iR1510
iR1530
iR1570F

iR1200S-011 Rev. 1
(F1-T01-0L6-10005-02)

Points to note for servicing in association with changes of LCD control panel and controller PCB

F-1

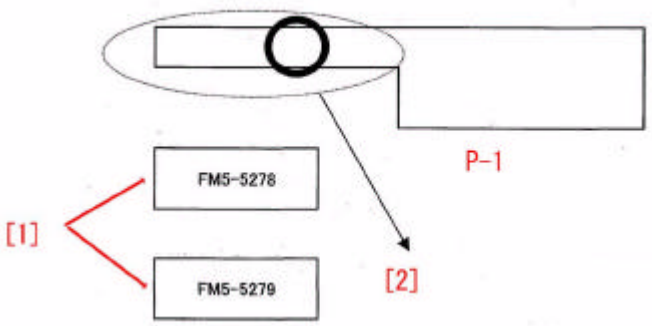
The LCD control panel and the controller PCB are changed for reasons of procurement. After these changes, the two parts are not compatible in combination of the old and new parts. This bulletin is prepared to inform the points to note for servicing.

Both the old and new parts of the LCD and the controller PCB are stocked as service parts. When replacing the LCD or the controller PCB, be sure to check if it is the old type or the new type (a part number label is affixed on the back of the new-type part as shown in the illustration below), and replace the old type with the old type, and the new type with the new type.
